PROPOSED RESERVOIR, STEMSTER HILL, WICK

PROPOSED RESERVOIR, STEMSTER HILL, CAITHNESS

CAITHNESS REGIONAL WATER
REPORT
PROPOSED RESERVOIR AT STEMSTER
SCALE 1:500

PROPOSED LOCATION FOR RESERVOIR

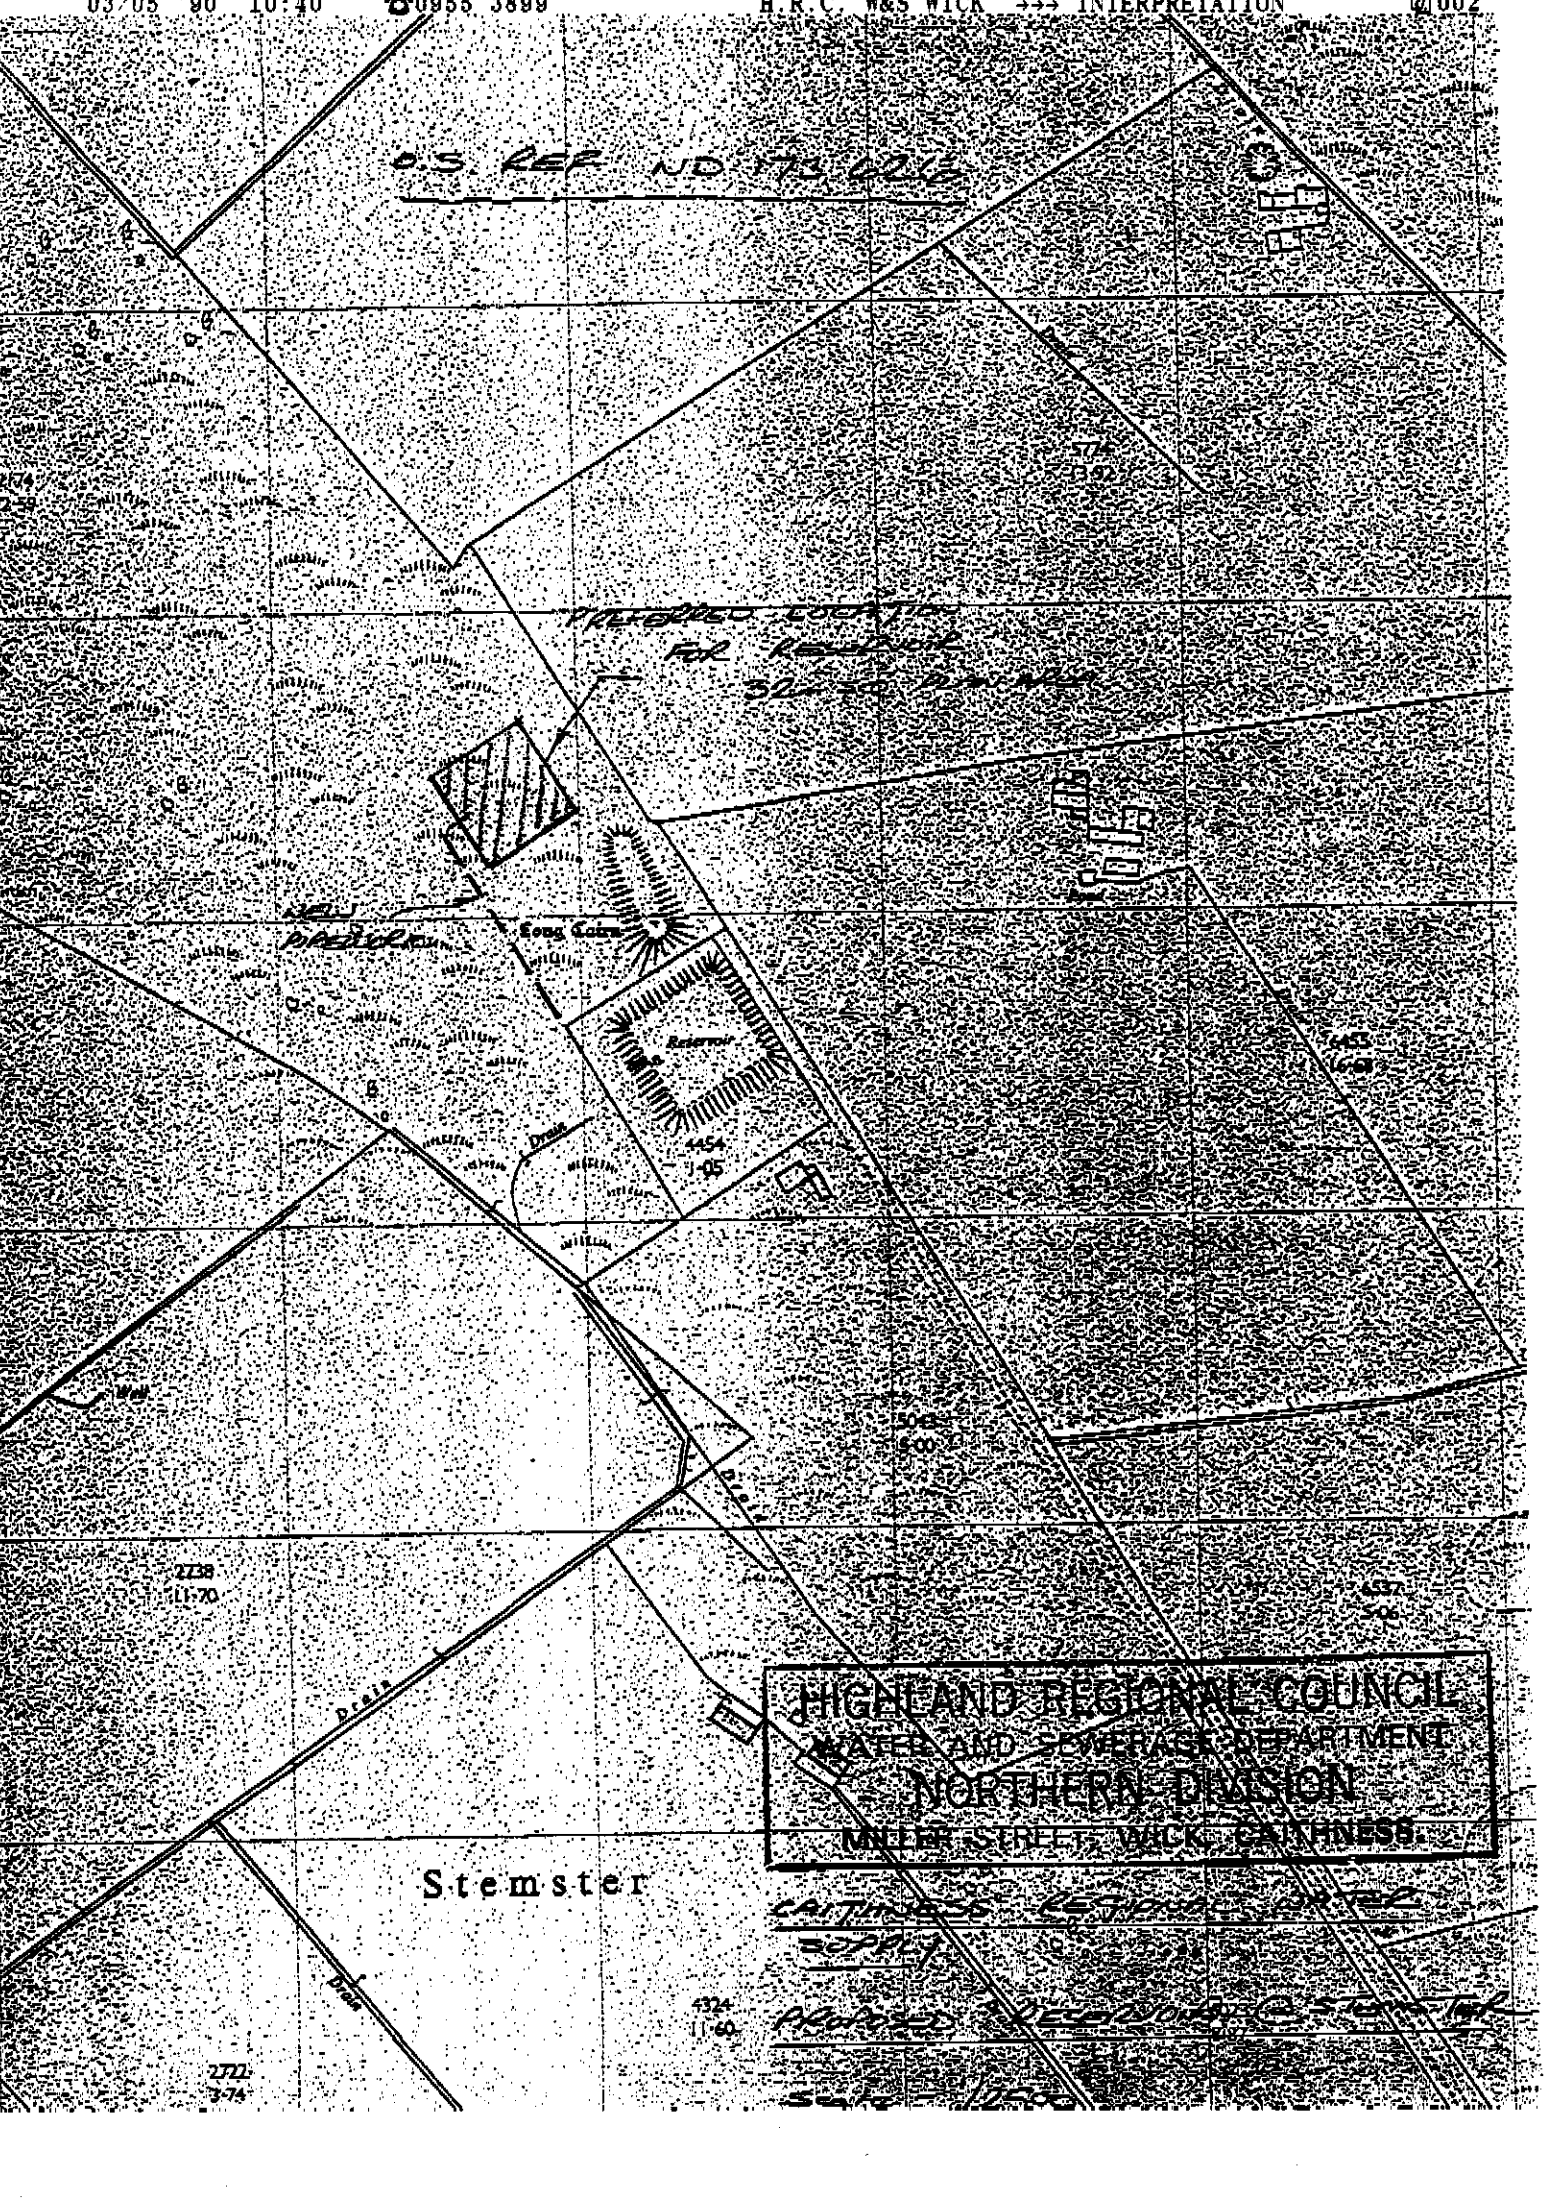
While I am uncertain of your specific needs, there seems to be space to locate the reservoir to the north without encroaching on the monument - or at least as little as possible. Can you suggest alternative locations which would be viable (I think obviously they would mean a longer linking line) and sketch them on the map for me?

In view of the cairn, I think it is quite possible that there may be other, associated archaeological remains now invisible almost anywhere on this hilltop, and I think that we should undertake at least a watching brief when topsoil comes off, and possibly trial trenching of the area which would be affected. Have you any funds which might cover such work, as a professional archaeologist would probably have to be brought in due to my workload?

Finally, can you enlighten me on the degree of earth-moving necessary or otherwise: depth a width of linking pipe trench, and the depth, etc of the reservoir base itself, plus any immediately adjacent ground which would be unavoidably disturbed? I would be most grateful, and am sure we can come to a satisfactory solution at the end of the day.

It is possible, though uncertain, that the site was excavated at the turn of the century, and for present purposes it is assumed that this has not taken place, and the site is undisturbed, although much damaged. The area around the sites is also important, and although the pipeline shown on the map lies perhaps 20-25m from the drawn cairn, there may be archaeological features in the vicinity. Any test cores or pits should therefore be under archaeological supervision, and I would hope that I would be able to do this with adequate forewarning. Ideally, the topsoil should be taken off the ~~line~~ ^{reservoir area} along the line of the pipework, and the trench investigated for archaeological features before the trench itself is excavated - with someone on hand to record if necessary.

I will pass a copy of this memorandum to Historic Buildings and Monuments for their comments, and ask them to respond directly to you if they have further concerns. It may be that they would wish to fund excavation of the reservoir area itself, as this may also be the site of early activity associated with the cairn. Is it possible to move the reservoir a little way to the north to avoid the cairn by a wider margin? If so, this would be more acceptable.
